## ADDENDUM NO. 2

### **FY26 Stormwater Improvements**

City of Seminole

February 4, 2026

**DEMOLITION, EROSION & SEDIMENT CONTROL PLAN**

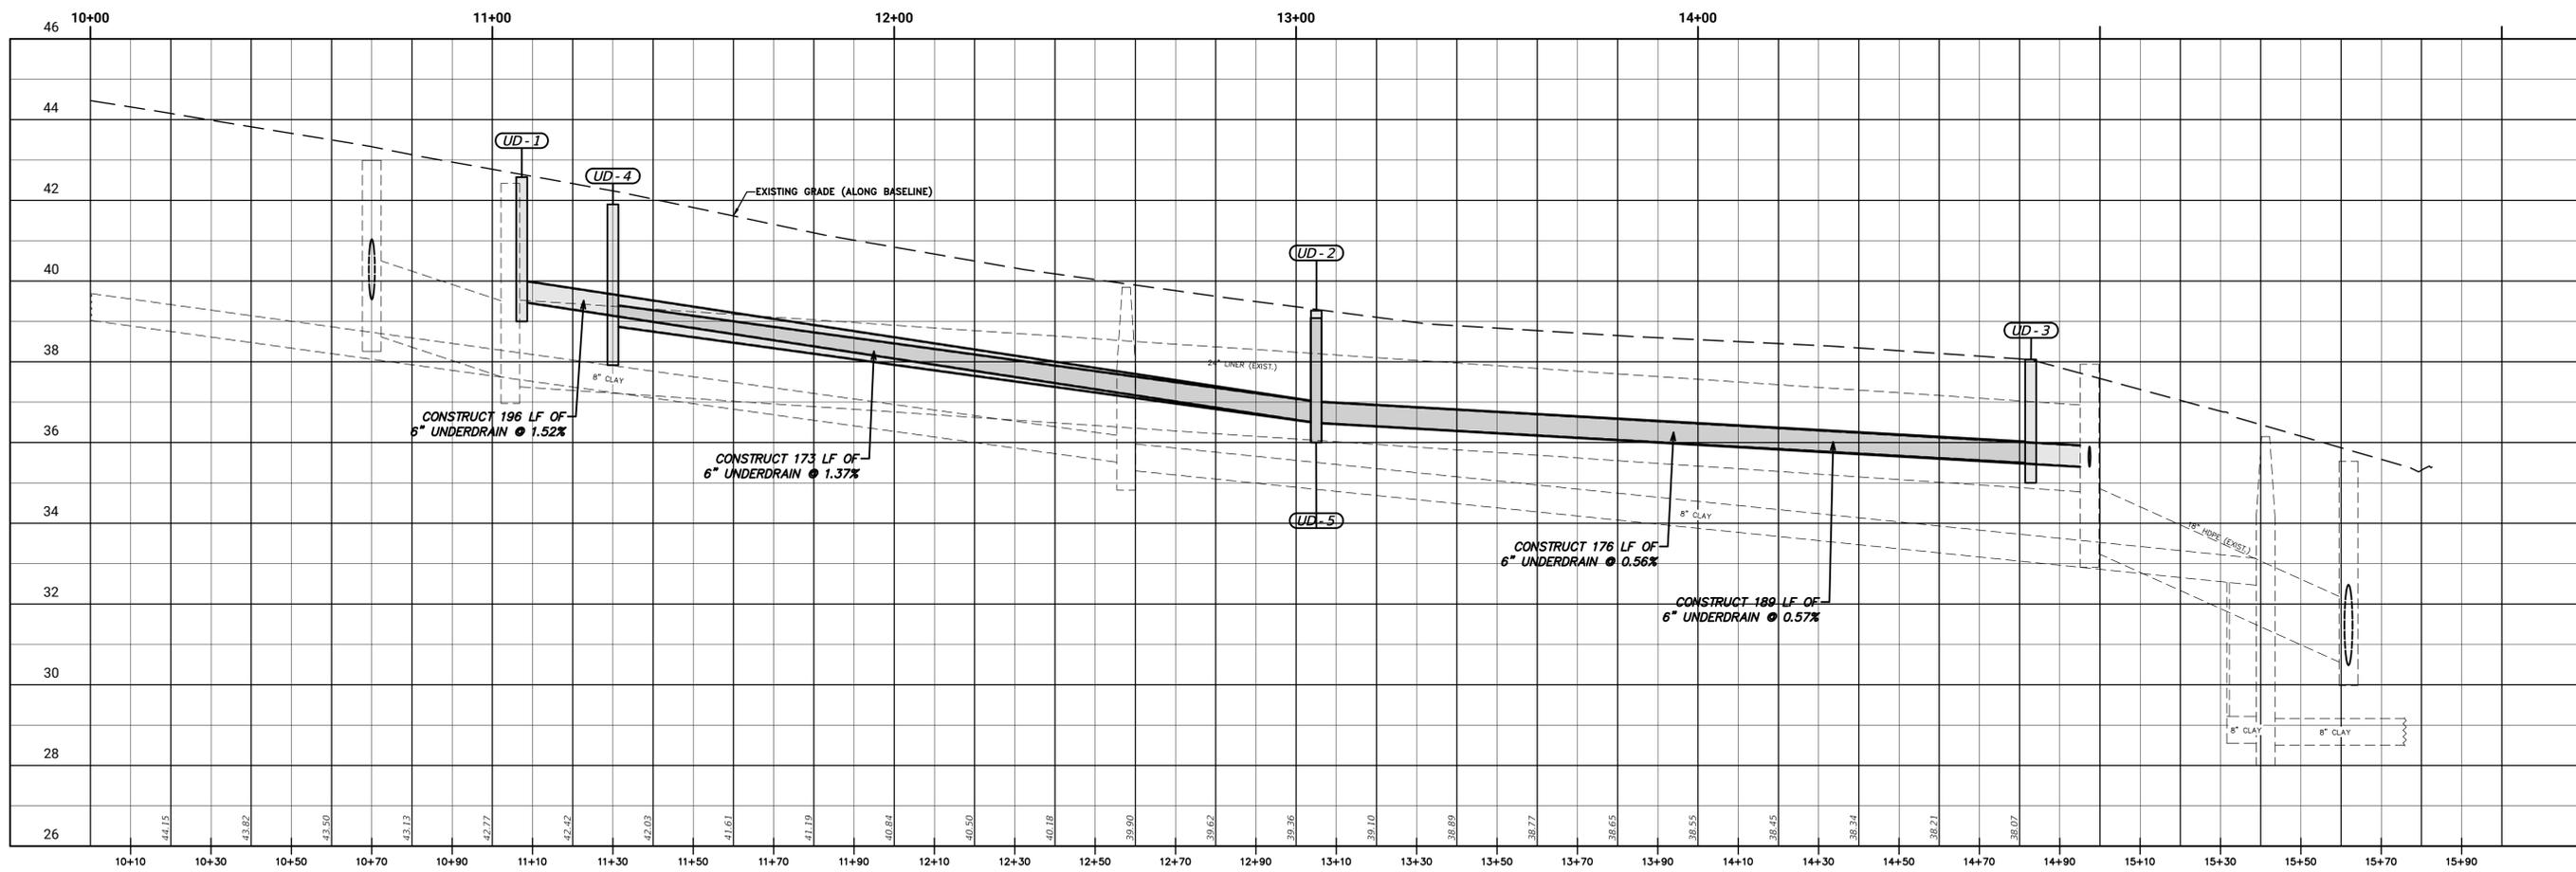
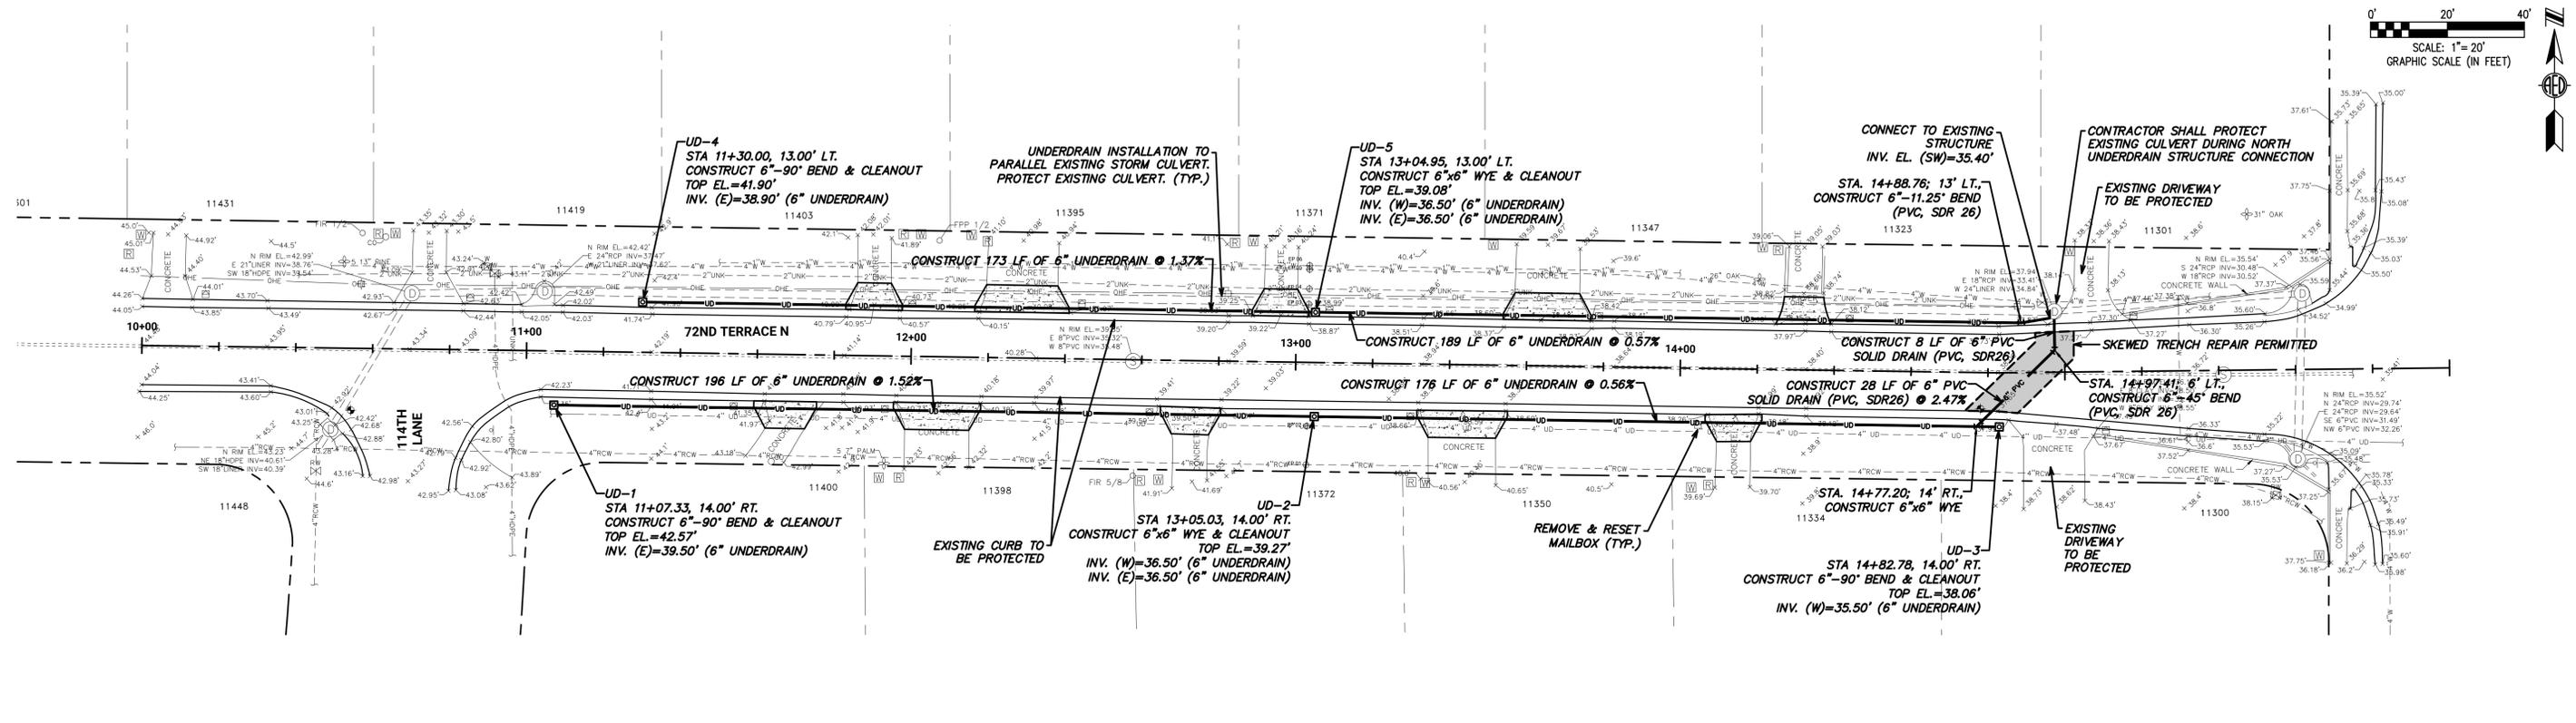
RSQ.1 For location one, both the 2” watermain removal and the existing 24” drainage pipe have X’s indicated in the demolition sheet but only the watermain removal is called out and has a line item in the SOV. Is the 24” drainage pipe to be removed as well?

*The 24” drainage is to be removed. The cost associated with this effort should be incorporated within ITEM A-G-3, as this item includes “stormwater structure and pipe demolition.” Separate payment for stormwater pipe removal will not be provided.*

**1 WALL PENETRATION REPAIR**  
NOT TO SCALE

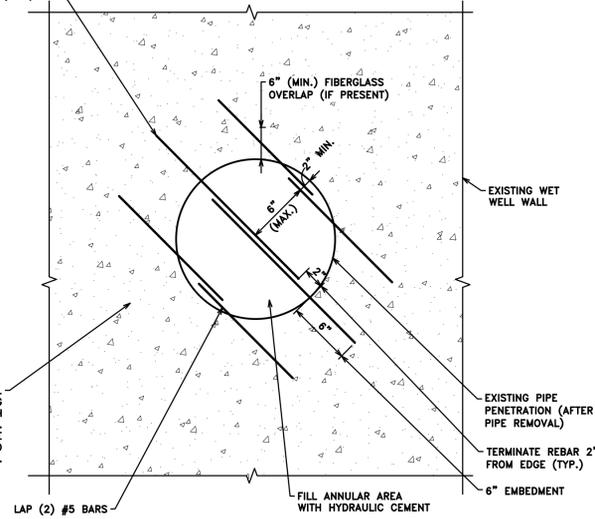
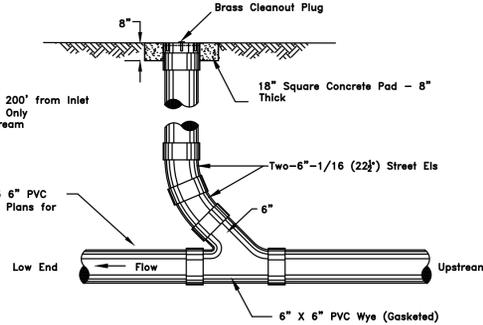
Details for underdrain cleanouts and wall penetration repair have been added to the plans.

RSQ.2 For location one, are any additional details available for the “existing high pipe wall penetration to be repaired” as mentioned in the cross section sheet?

*A detail was added to the plans to address this question.*

DRILL 3/8" Ø HOLE & CLEAN. PLACE SIMPSON SET EPOXY IN DRILLED HOLE. PLACE REBAR (TYP.)

CLEAN EXISTING WALL PRIOR TO PERFORMING REPAIR USING HIGH PRESSURE WATER SPRAY. USE CAUTION TO ENSURE NO DAMAGE OCCURS TO EXISTING LINER.
